**ZONING BOARD OF ADJUSTMENTS  
AGENDA**

Continued public hearing on the request of Heartland Co-Op, represented by David Hoylman from ABP Engineering, for a conditional use permit to allow the expansion of a 'grain storage and distribution' facility in an I-2 District on property legally described as being part of the South 1/2 of Section 4-74-44, lying east of the Missouri River and west of River Road. Location: 2401 South 37th Street

# CITY OF COUNCIL BLUFFS - ZONING BOARD OF ADJUSTMENT CASE #CU-22-004 LOCATION/ZONING MAP

# HEARTLAND GRAIN FACILITY RECEIVING AND STORAGE - BARGE LOADOUT COUNCIL BLUFFS, IOWA

SITE PLAN

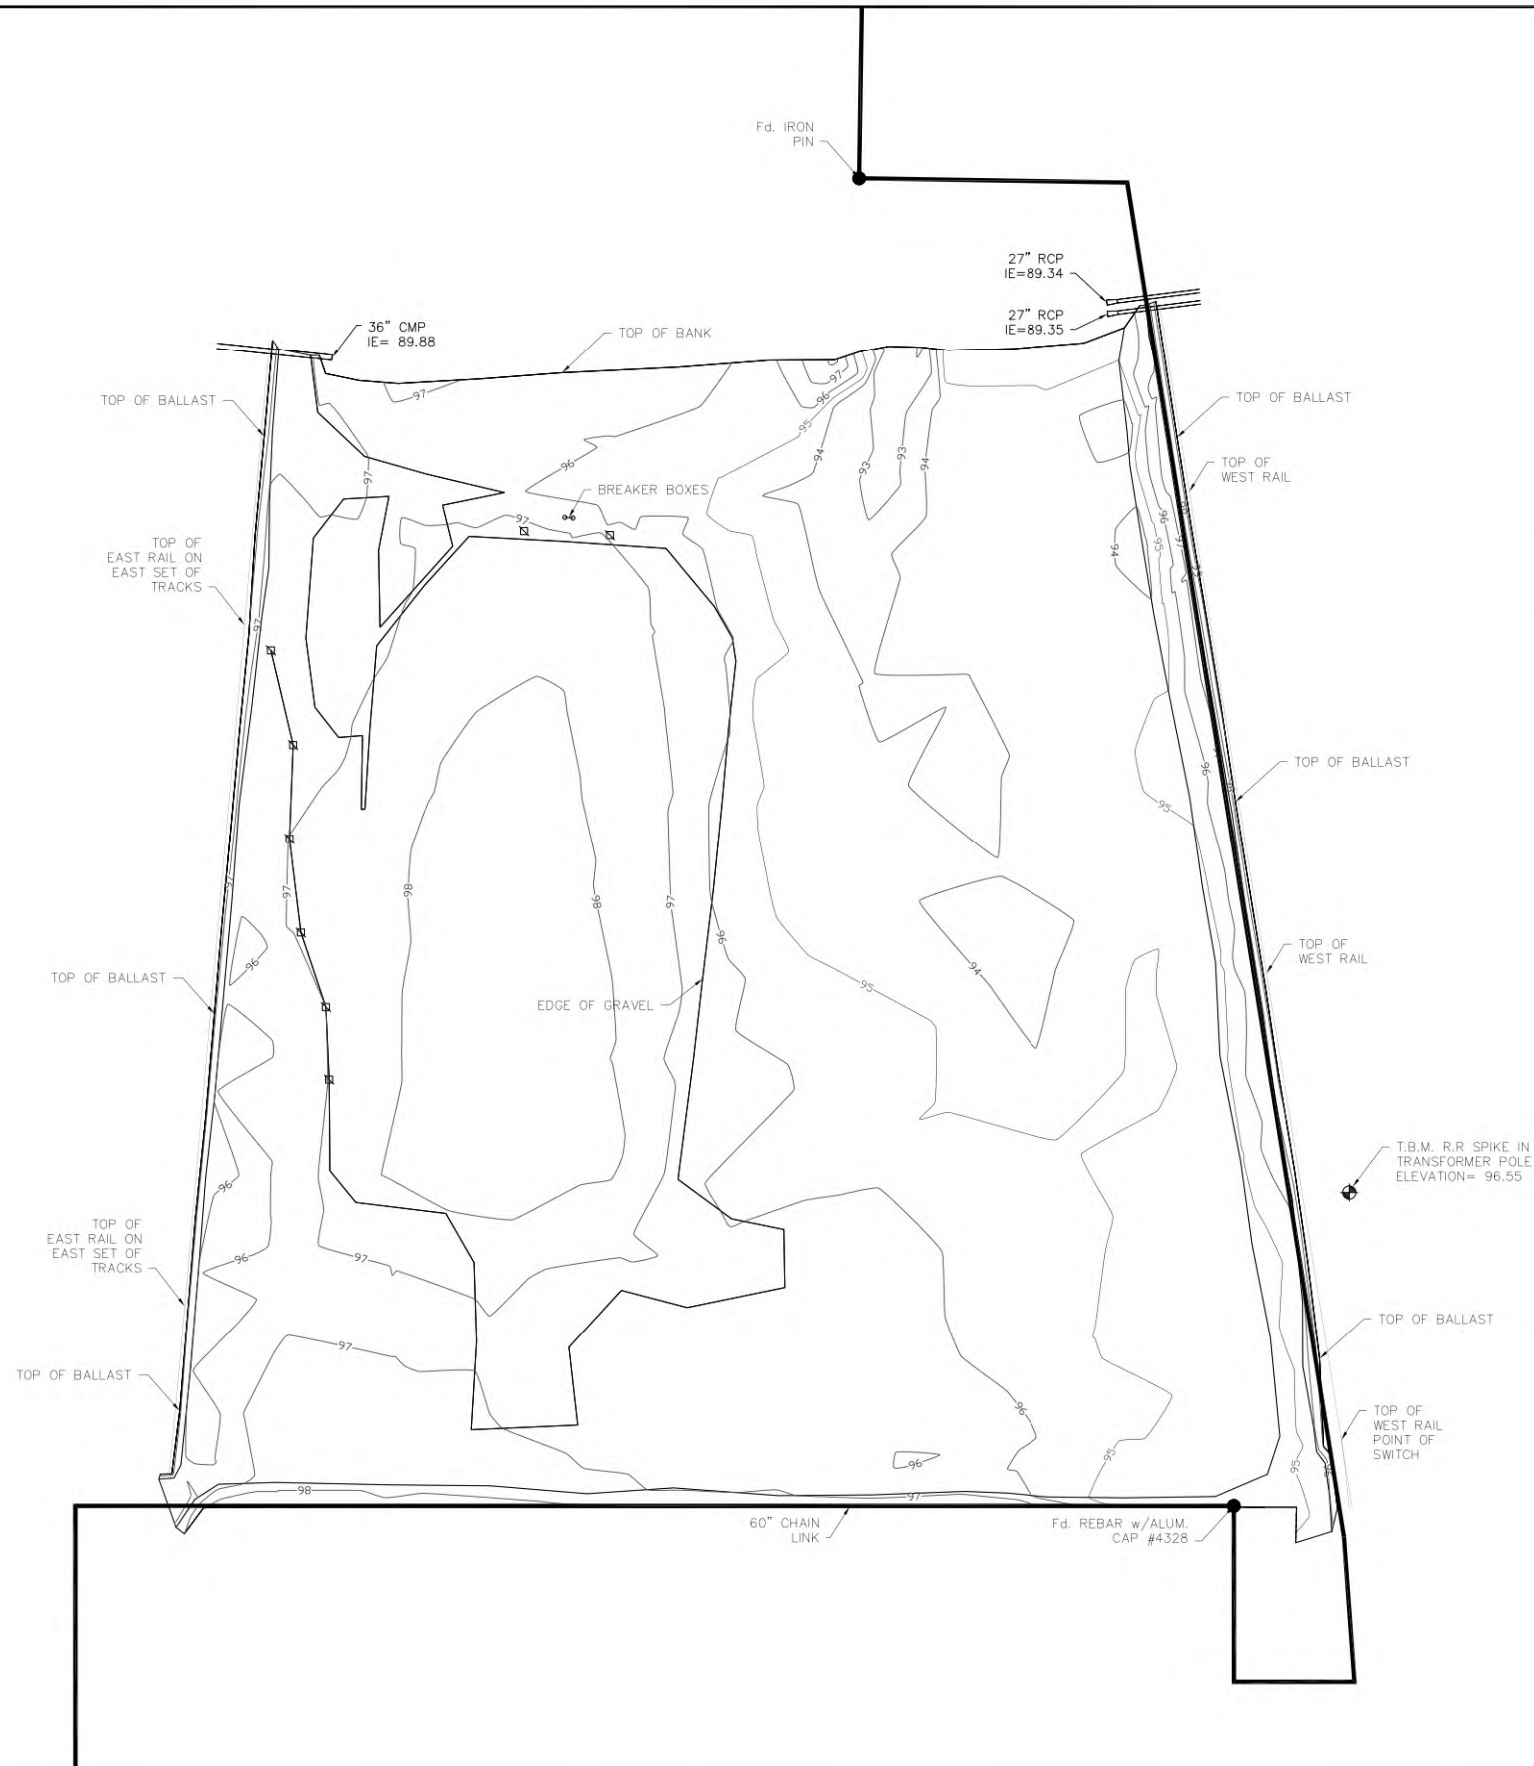
- a. The boundary of the subject property shown on the submitted site plan in Attachment 'D' does not coincide with the property boundary shown on the Pottawattamie County online GIS map. The applicant shall confirm the location of all property lines and submit a revised site plan or a survey at the time of building permit application that includes the correct course bearing distances for the subject property.

7. The submitted site plan in Attachment 'D' shows that an internal roadway for truck circulation and a new employee parking area will be constructed as part of this project. The proposed parking area and internal roadway shall be subject to the following off-street parking requirements:

8. The submitted site plan in Attachment 'D' shows new 30-foot tall light poles will be installed on the subject property as part of this project. All outdoor lighting shall comply with Section 15.24.050, *Lighting Controls*, of the Council Bluffs Municipal Code (Zoning Ordinance). The height of the proposed light poles is acceptable. All light poles shall be painted or finished aluminum or steel. Wood poles shall not be allowed. Cut-off lenses shall incorporated to contain all light onsite and direct it away from the vision of passing motorists, cyclists and pedestrians. The applicant shall submit a photometric plan that shows the amount of lighting that will be generated as part of this project prior to installation.

- District signage standards. A separate permit shall be required for all proposed signage prior to installation.
10. The submitted site plan in Attachment 'D' shows new railroad track lines will be installed as part of this project. The applicant shall coordinate the location of the new track line with the owner of the adjacent railroad. The applicant shall be responsible for establishing any cross access easements necessary for the new track lines.

11. The submitted site plan in Attachment 'D' shows that several propane tanks will be stored on railroad right-of-way. Due to the inconsistency of the property boundary shown in Attachment 'D', at this time it is not certain whether the propane tanks will be located outside the subject property. All outdoor storage of propane tanks shall occur entirely within the subject property. Alternatively, the applicant shall provide proof of an agreement with the railroad that indicates the outdoor storage of propane tanks associated with the 'grain storage and distribution' facility will be allowed on the right-of-way.

12. The submitted site plan in Attachment 'D' shows a new loading tower, conveyor equipment and dolphins will installed on the Missouri River as part of the applicant's proposal to restore the capability of loading out grain to barges. All proposed improvements that impact the IPL levee system and/or the Missouri River shall be reviewed and approved by the U.S. Army Corps of Engineers and the City of Council Bluffs.

3. The hours of operation shall be Sunday through Saturday 7:00 A.M. to 4:30 P.M.
4. The applicant shall confirm the location of all property lines and submit a revised site plan or a survey at the time of building permit application that includes the correct course bearing distances for the subject property.

8. All outdoor lighting shall comply with Section 15.24.050, *Lighting Controls*, of the Council Bluffs Municipal Code (Zoning Ordinance). The height of the proposed light poles (30'-0") is acceptable. All light poles shall be painted or finished aluminum or steel. Wood poles shall not be allowed. Cut-off lenses shall be incorporated to contain all light onsite and direct it away from the vision of passing motorists, cyclists and pedestrians. The applicant shall submit a photometric plan that shows the amount of lighting that will be generated as part of this project prior to installation.

12. All outdoor storage of propane tanks shall occur entirely within the subject property. Alternatively, the applicant shall provide proof of an agreement with the railroad that indicates the outdoor storage of propane tanks associated with the 'grain storage and distribution' facility will be allowed on the right-of-way.

DEPARTMENT:	N/A	DRAWING NUMBER:	21155-GA-101	REV:	C
-------------	-----	-----------------	--------------	------	---

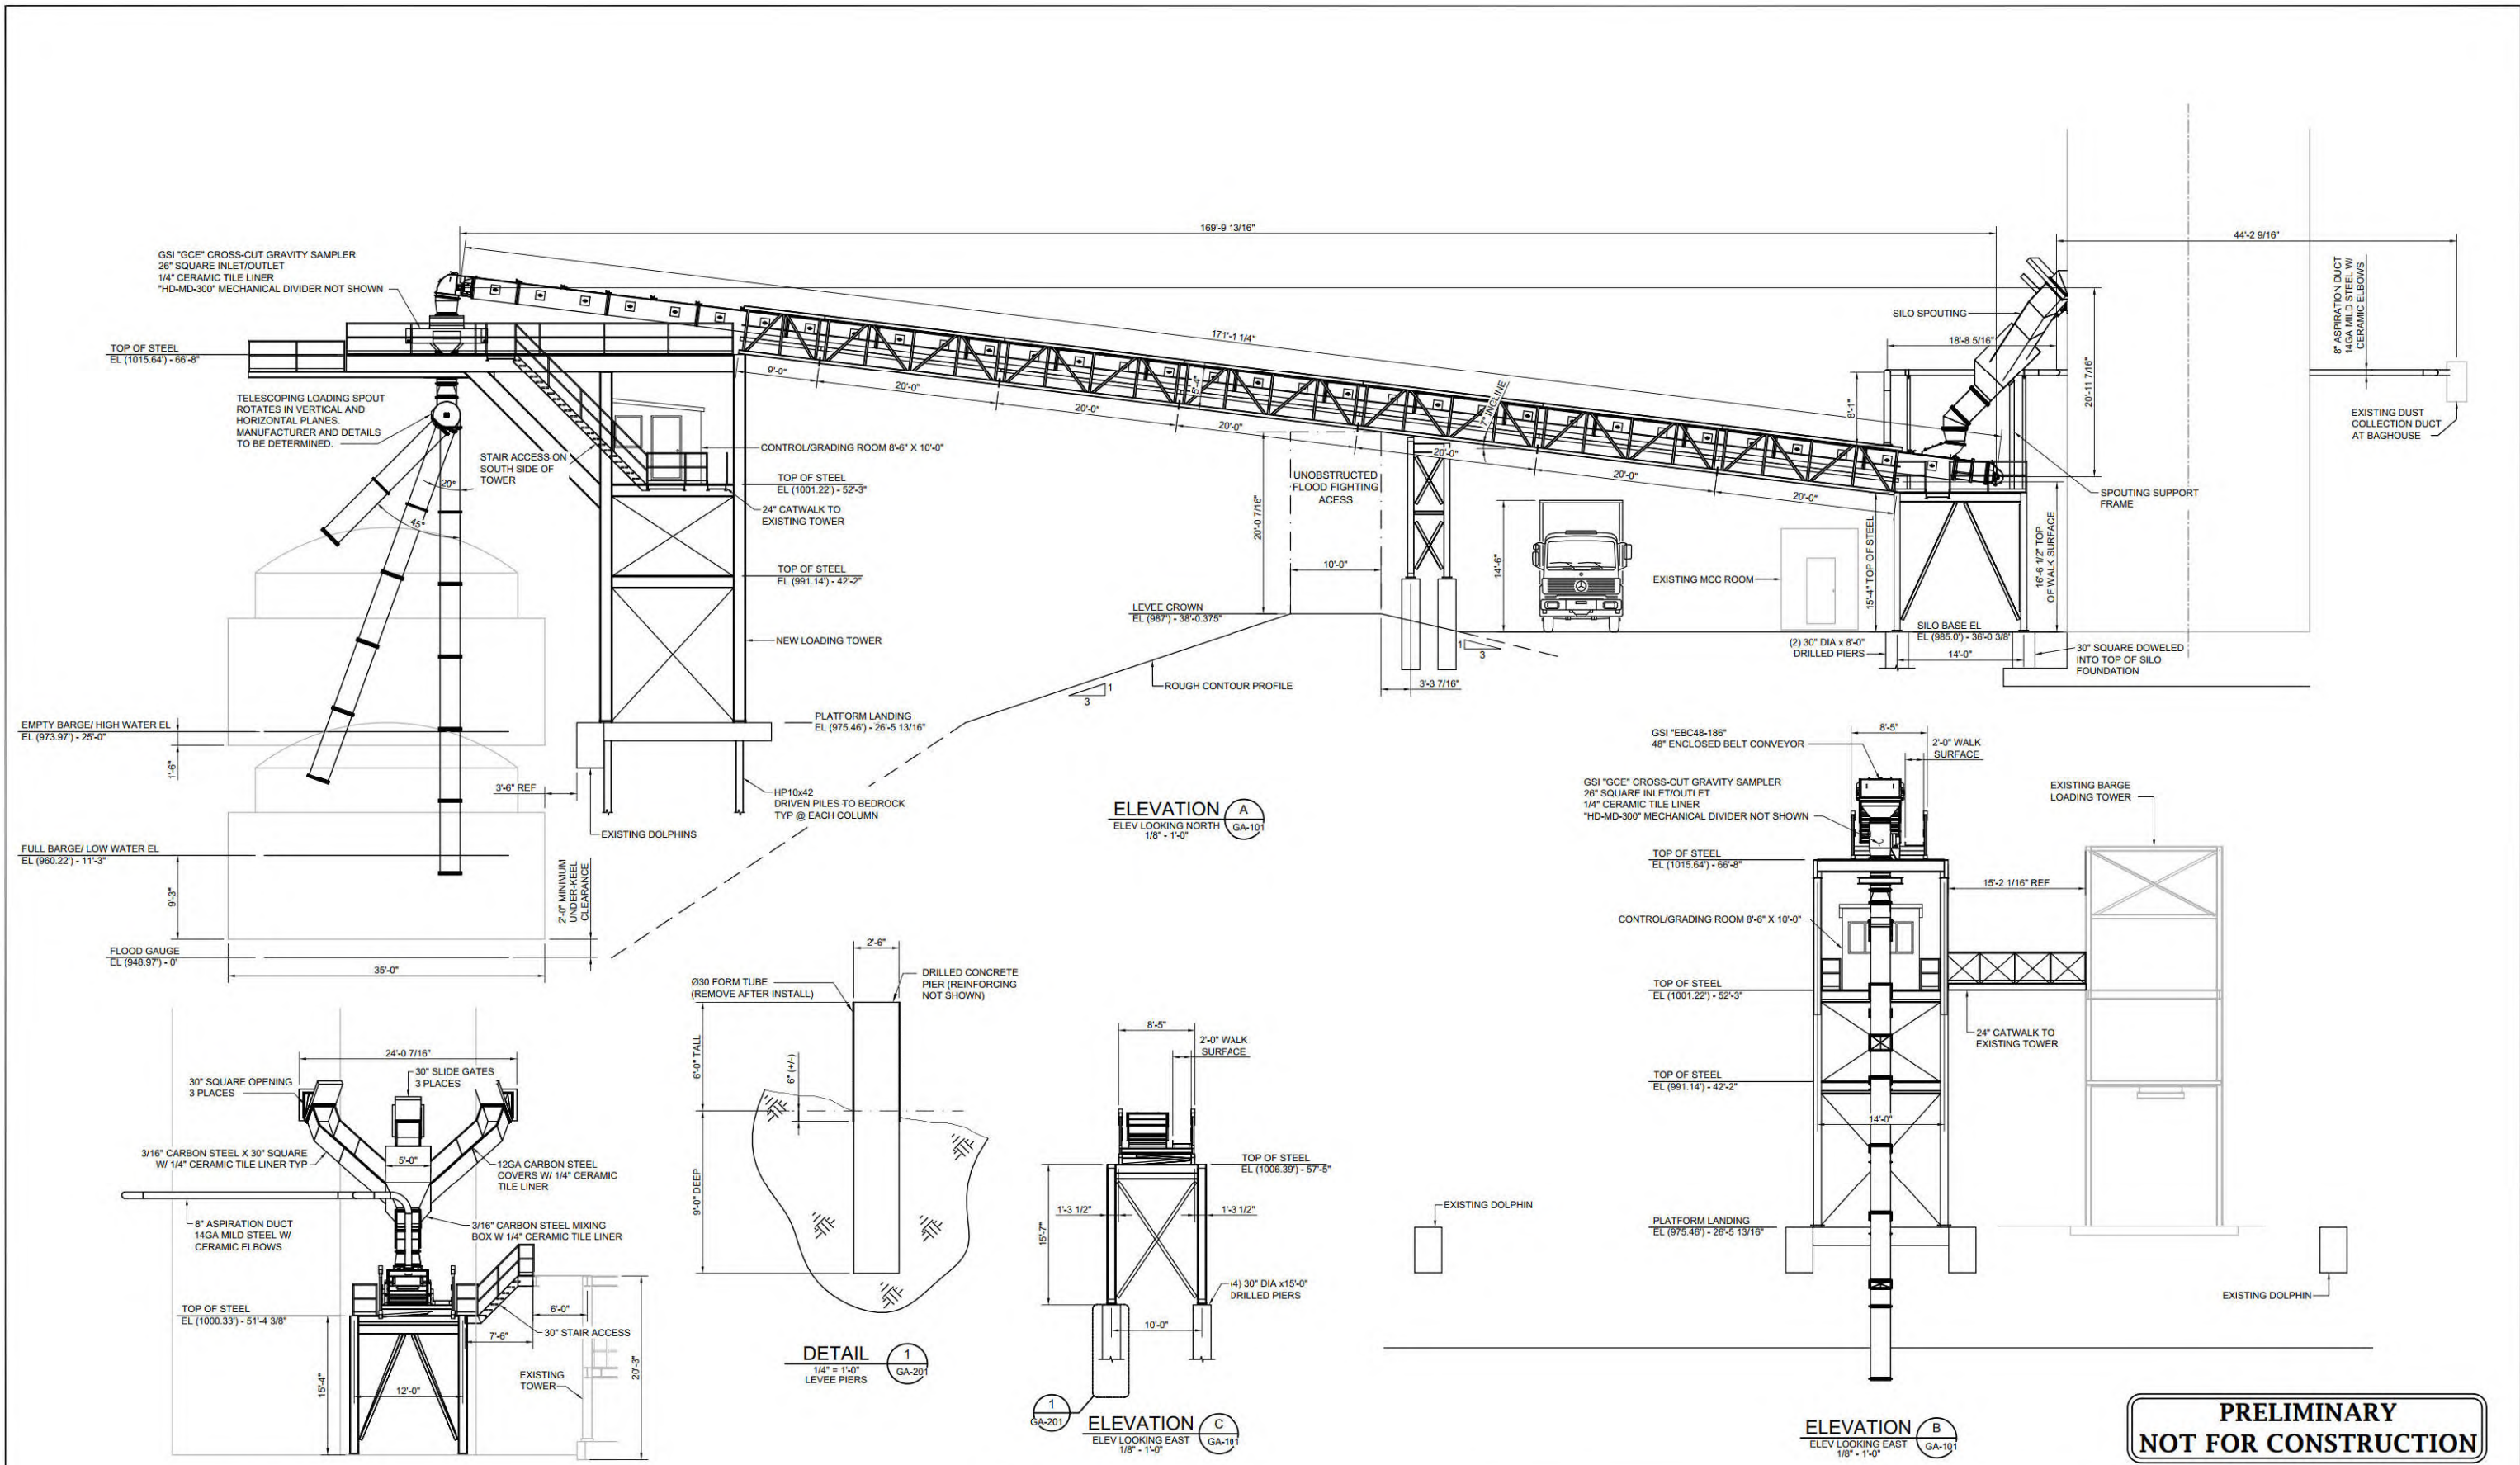
ABP has added a General Note to attached drawings 21155-GA-101 and 21155-GA-201 calling for backfill and repair per the specified document.

ABP has added a General Note to attached drawings 21155-C-101, 21155-GA-101, and 21155-GA-201 calling for the owner to provide inspection and observation services by the design engineer.

DEPARTMENT: N/A  
DRAWING NUMBER: 21155-GA-201  
REV: C

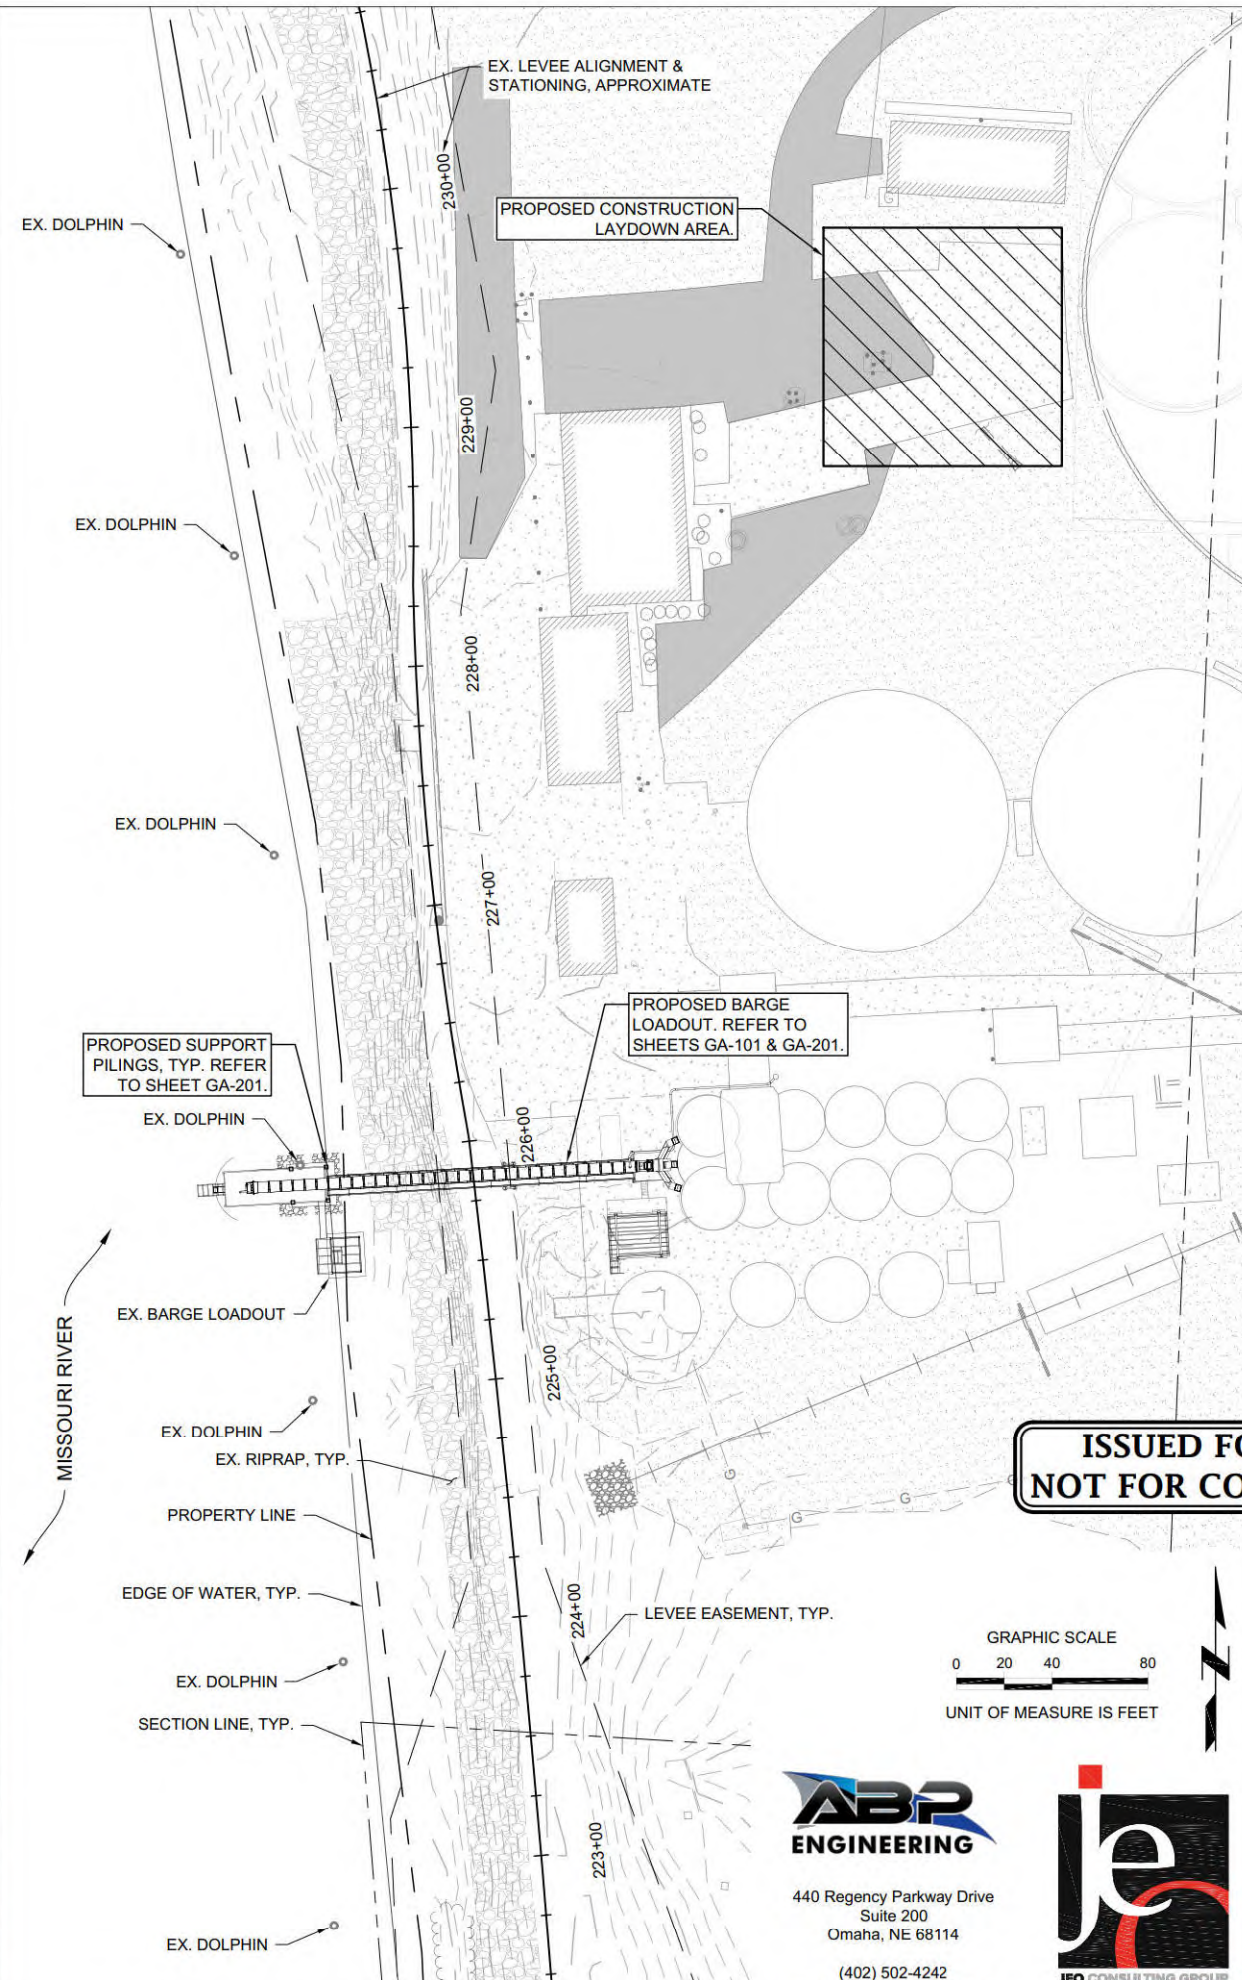
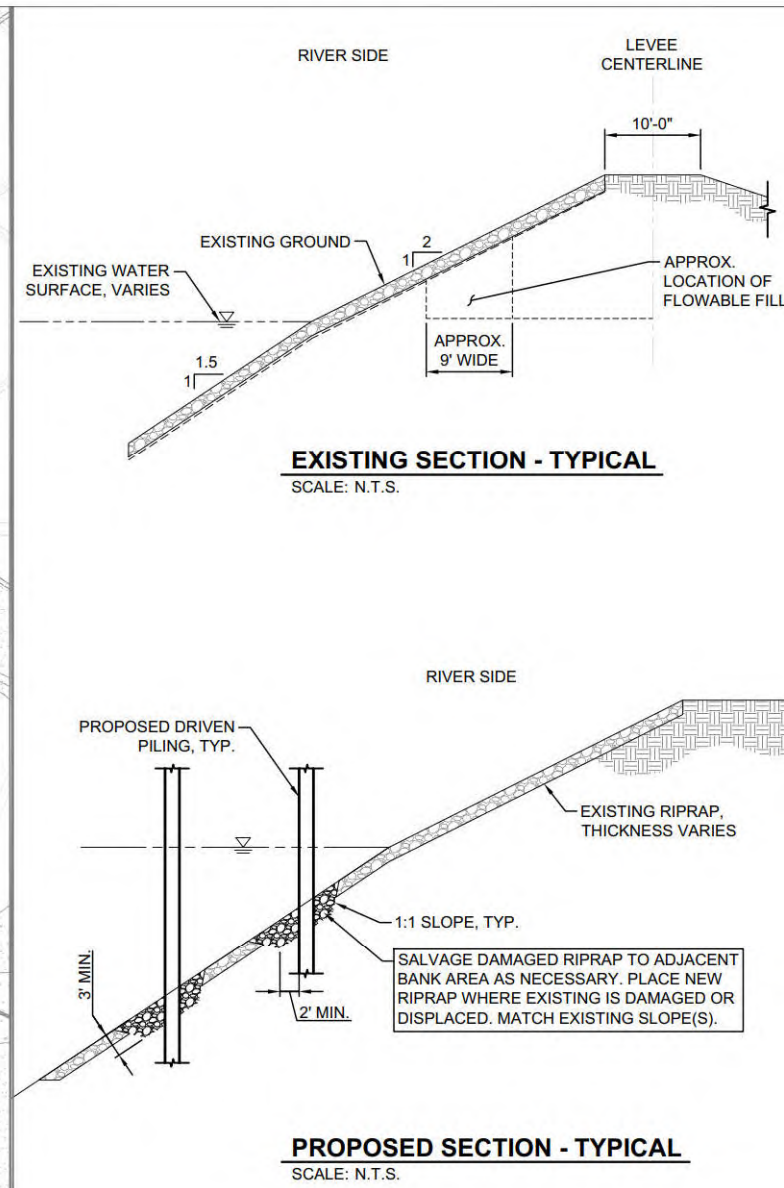
The levee prism has been added to drawing 21155-GA-201, as requested.

Drilled piers on the land side will be hydroexcavated and removed earth will be replaced with steel reinforced concrete piers. ABP has added a detail view to drawing 21155-GA-201.

Flood fighting access has been added to drawing 21155-GA-201.
